ELECTRONICS FIELD CHANGE BULLETIN  
NAVAL SHIP ENGINEERING CENTER, NAVY DEPARTMENT  
WASHINGTON, D. C.

24-AN/URC-32  
10-AN/URC-32A  
7-AN/URC-32B  
15-KWT-6(8)

ADDS CONSTANT VOLTAGE TRANSFORMER 2T2

PURPOSE: To provide a regulated 118 volt AC source to the input of the P.A. filament and bias transformer 2T1, located within the Radio Frequency Amplifier AM-2061/URT.

FIGURE I.

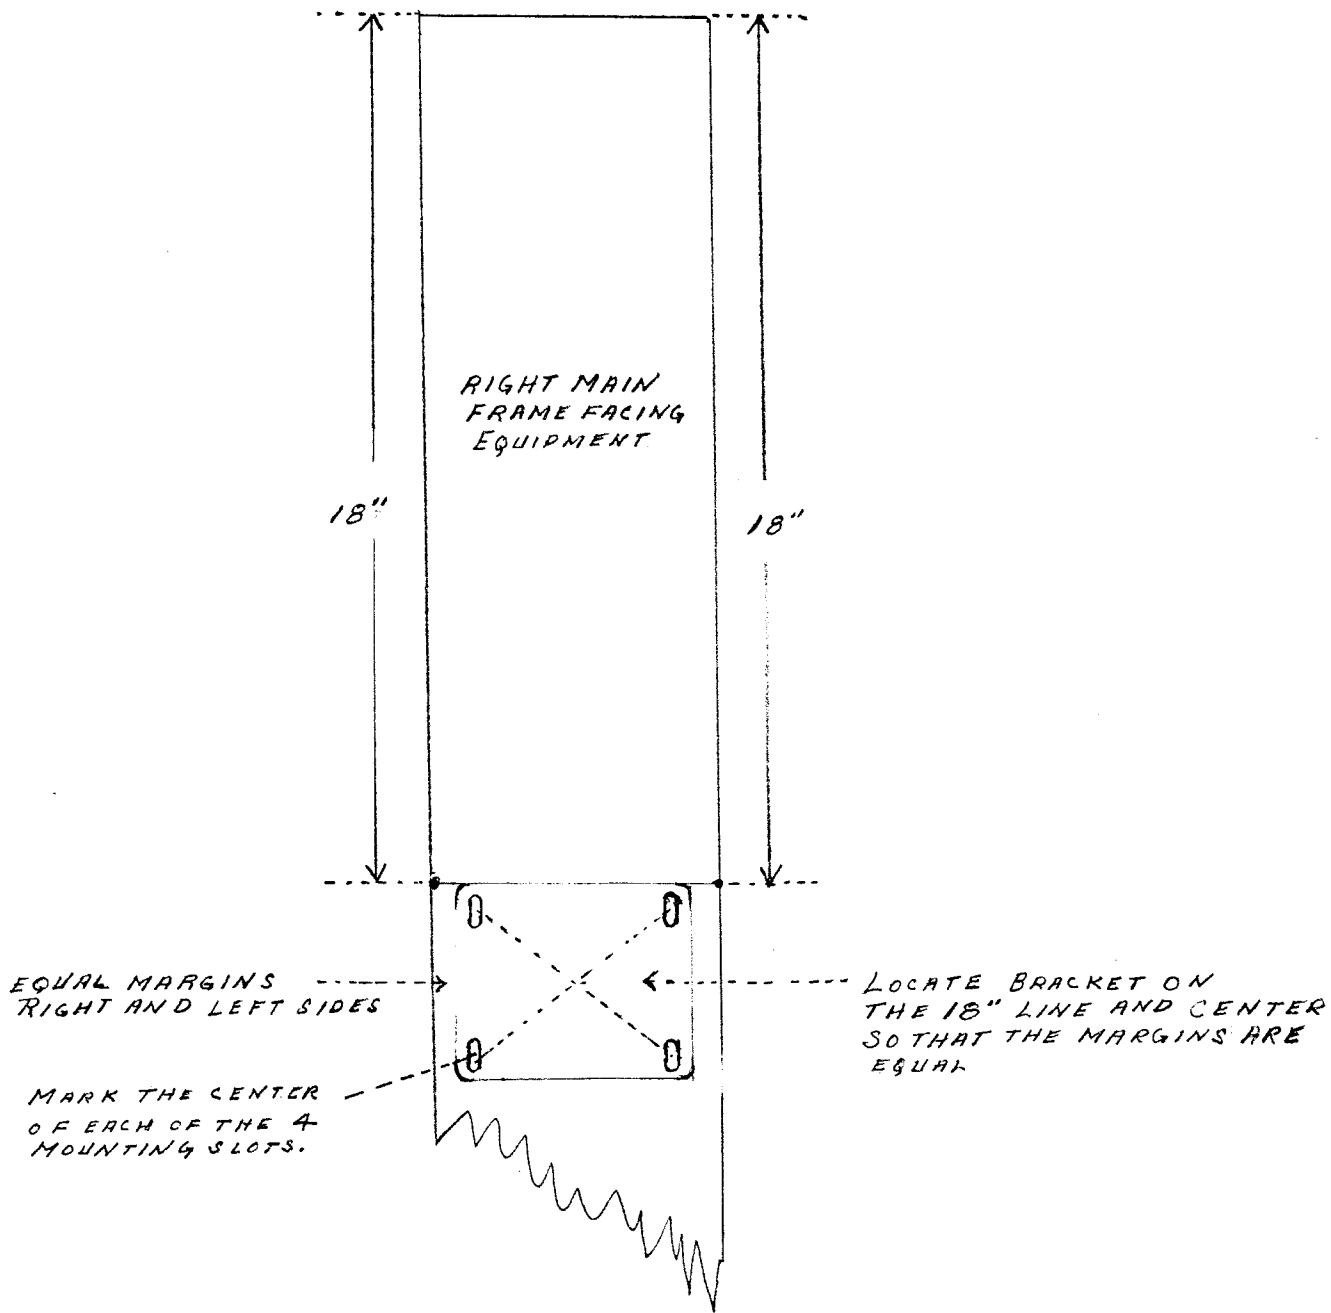
3. Remove the cover from the J1007/U junction box.
4. Refer to Figure 1. Measure down 18 inches from the top of the right main frame of the MT-2092/U electrical equipment rack. Draw a line across the face of the frame. Temporarily remove the mounting bracket from the constant voltage transformer (Item 1) in order to use it as a template for locating the mounting holes. Place the top edge of the bracket on the 18 inch line, divide the right and left margins evenly and mark the centers of each one of the four mounting slots. Center punch each of the four centers and drill a 9/32" hole at each of the four centers.

5. Replace the mounting bracket on the transformer. Mount the transformer inside the channel of the main frame. Use the four screws 1/4"-20 X 1", four flat washers, four lock washers, and four nuts in Item 3. Insert the screws from the outside of the frame with the washers and nuts on the bracket and transformer side.

FIGURE-2.

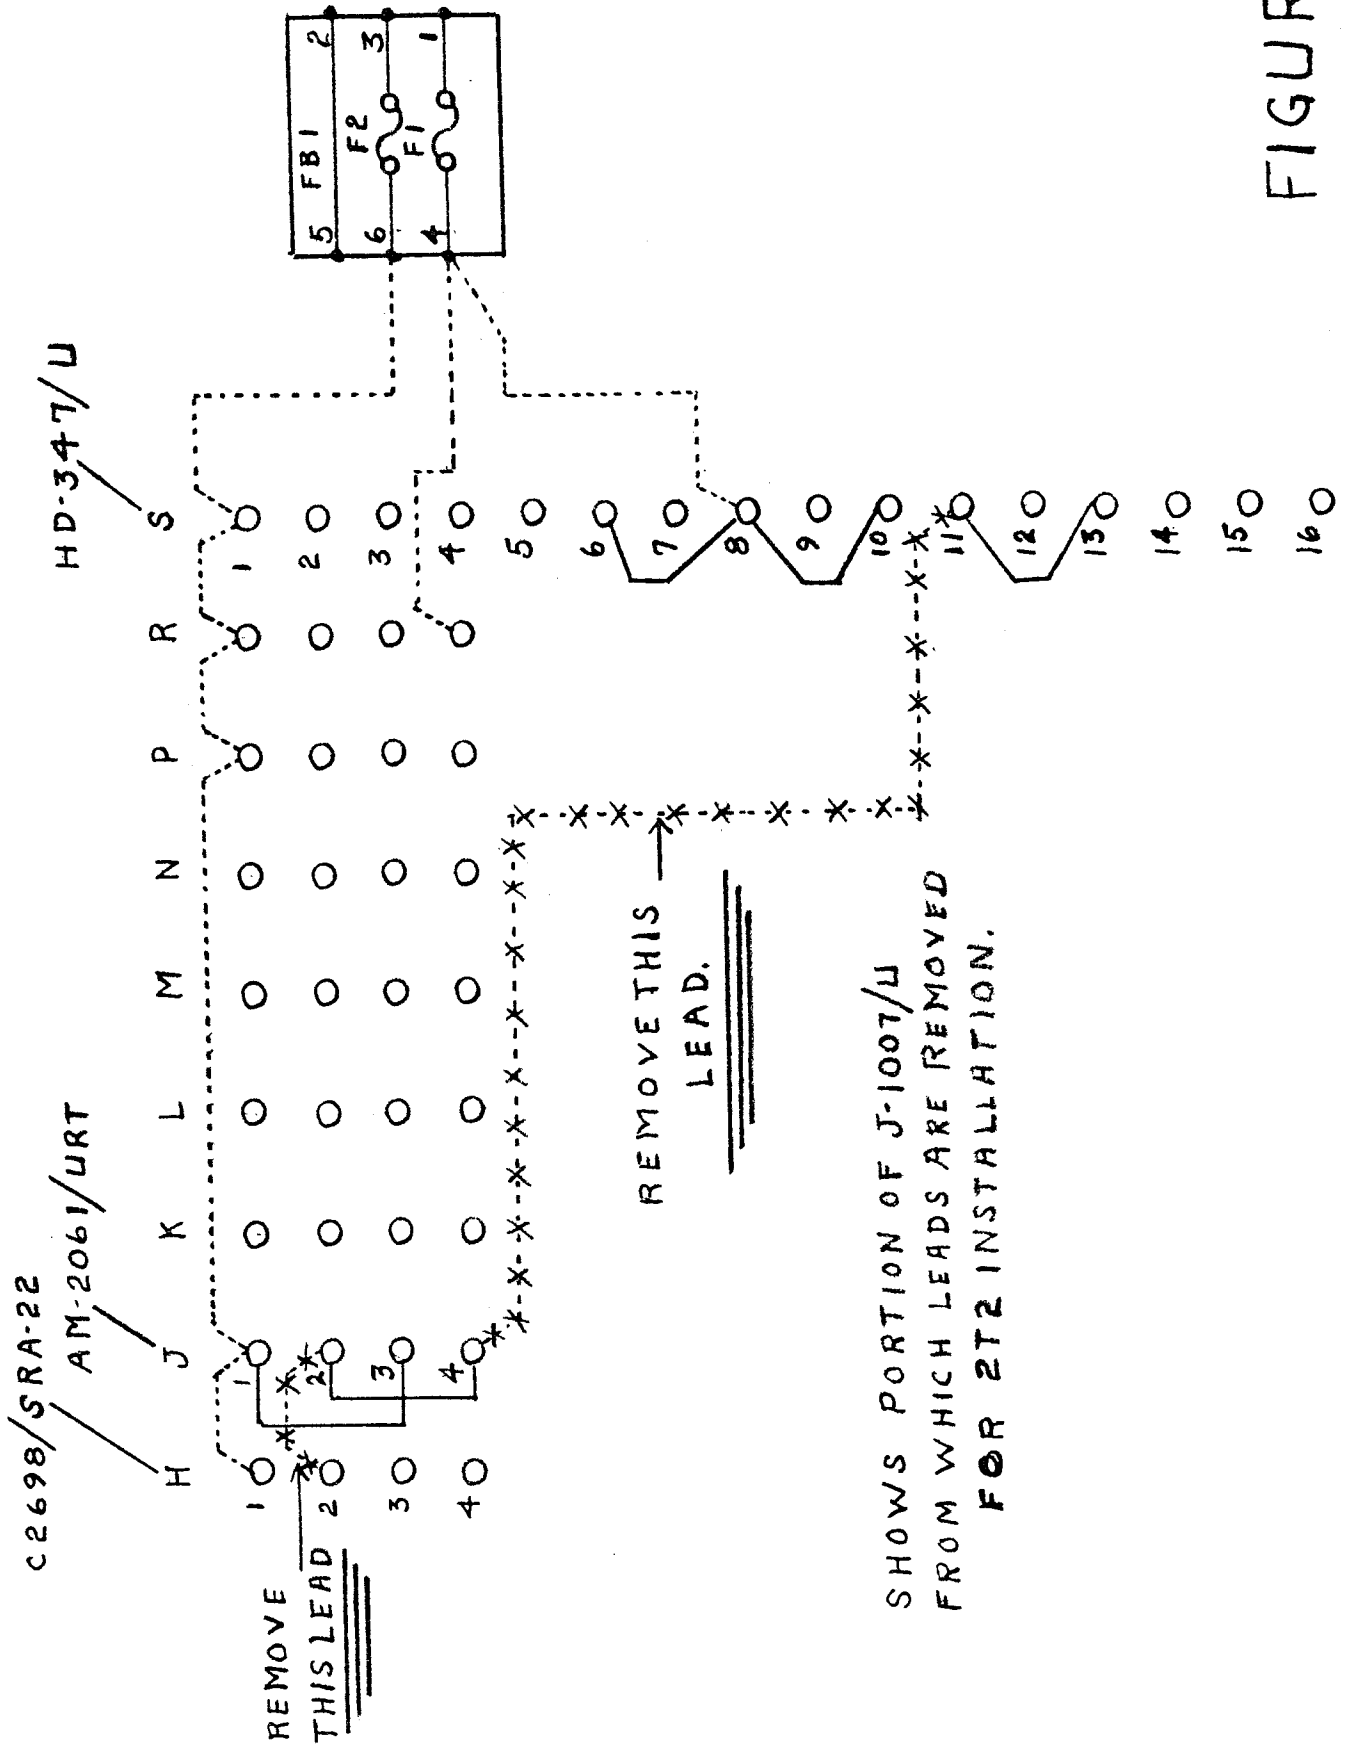
- 10. Refer to Figure 2. Locate on the bottom side of the J1007/U the jumper which connects terminal S-11 to terminal J-4. Remove this jumper.
- 11. Refer to Figure 2. Locate on the bottom side of the J1007/U the jumper which connects terminal J-2 to terminal H2. Remove this jumper.
- 12. Refer to Figure 3. Use the 10 inch piece of hook-up wire, Item 2, supplied with the kit, and connect terminal S-11 to terminal H-2 on the bottom side of the J1007/U.
- 13. Remove the screws securing the top cover of the constant voltage transformer (cover can be pushed up the cable harness) in order to gain access to the transformer terminal board TB-1. Verify with the AN/PSM-4 that the connections have been made correctly as follows:

SHOWS PORTION OF J-1007/U  
 WITH CONSTANT VOLTAGE  
 TRANSFORMER (2T2)  
 WIRED FOR 115 VAC OPERATION.

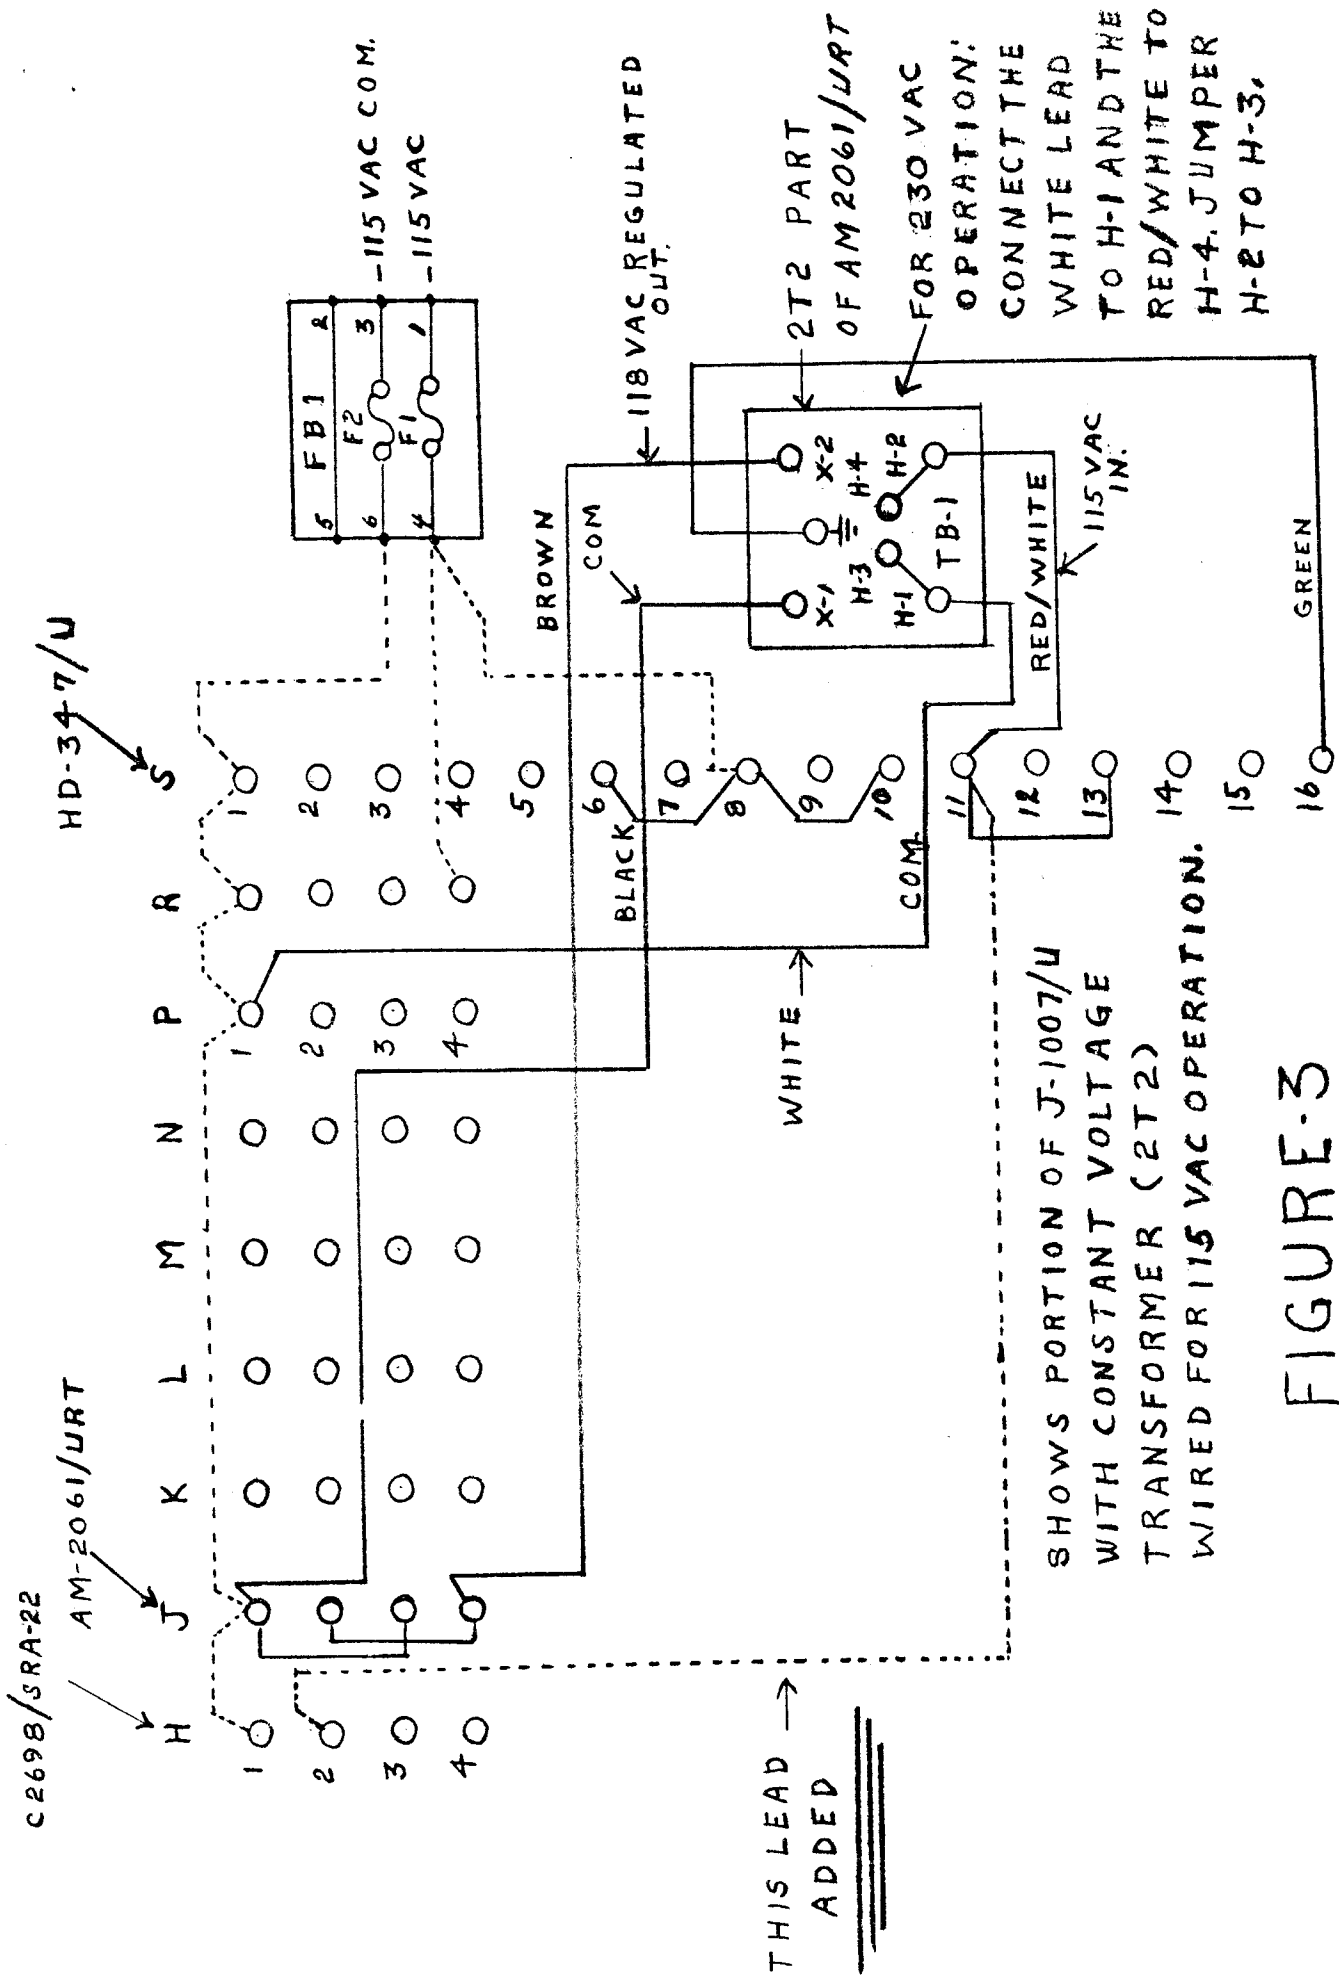
<u>J1007/U</u> <u>Terminals</u>	<u>Lead Color</u>	<u>Connected to</u> <u>TB-1 Terminals</u>
S-11	Red/White	H-2
S-16	Green	(ground)
P-1	White	H-1
J-4	Brown	X-2
J-1	Black	X-1

14. Verify by observation that the constant voltage transformer terminal board TB-1 is wired for 115 volt AC power input. Line input is connected to H-1 and H-2 (red/white lead connects to H-2, white lead connects to H-1). H-1 is jumpered to H-3, H-2 is jumpered to H-4. NOTE: For 230 volt AC operation, connect line input to H-1 and H-4 (red/white lead connects to H-4 and white lead connects to H-1). Jumper H-2 to H-3.

FIGURE 4.

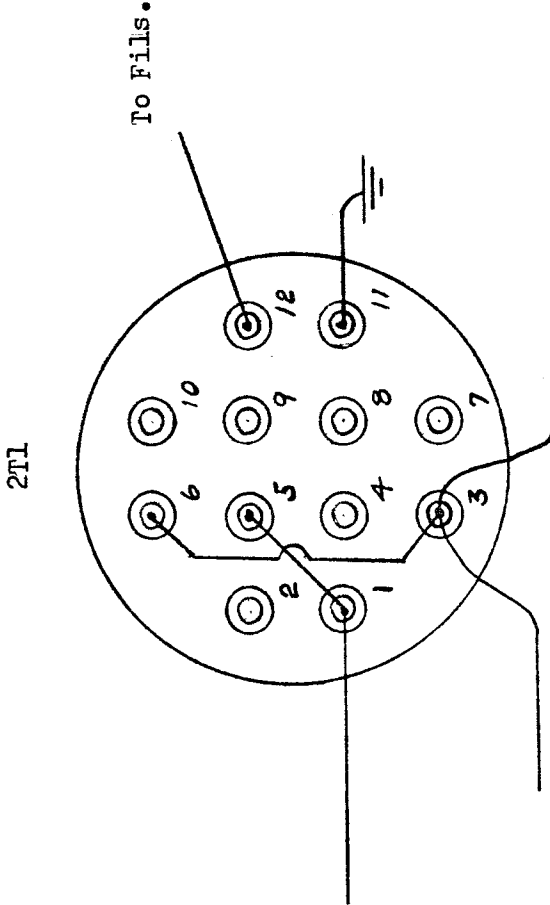
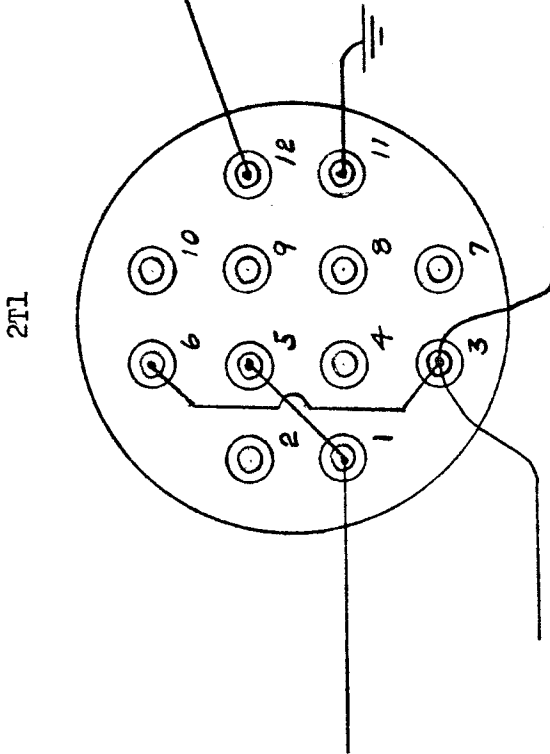
23. Turn the FIL OFF/TUNE/OPERATE switch on the AM-2061/URT to the TUNE position. Monitor the "6.0 V AC" test point on the AM-2061/URT with the AN/PSM-4. Note that 5.8 to 6.1 volt AC is indicated (NOTE: if the indication is below 5.8 volt AC, it is recommended that the tap connections on 2T1 which are located behind the front cover of the AM-2061/URT be changed from terminals 5 and 7 to 5 and 6. This may be necessary in order to compensate for the variations in filament currents of P.A. tubes from different manufacturers. (Refer to Figure 4.) Turn the FIL OFF/TUNE/OPERATE switch to the OFF position. Note the absence of the 5.8 to 6.1 volt AC. Turn the EXCITER R.F. GAIN control on the AM-2064/URC maximum CCW. Plate the FIL OFF/TUNE/OPERATE switch to the OPERATE position. 5.8 to 6.1 volt ac is indicated. Place the plate ON/OFF/KEY switch on the AM-2061/URT to the ON position. Place the XMIT/REC/CW TEST switch on the CV-730/URC to the XMIT position. If necessary, adjust the P.A. BIAS pot for a 150 milliamp indication on the AM-2061/URT "Plate Current" meter.

Filament portion of 2T1 showing change in wiring hook-up when filament voltage at 6.0 V AC Test Point is below 5.8 V AC.

1. Remove the jumper between terminals 3 & 7.
2. Change the wire connected to terminal 7 over to terminal 3.
3. Add a jumper between terminals 3 & 6.
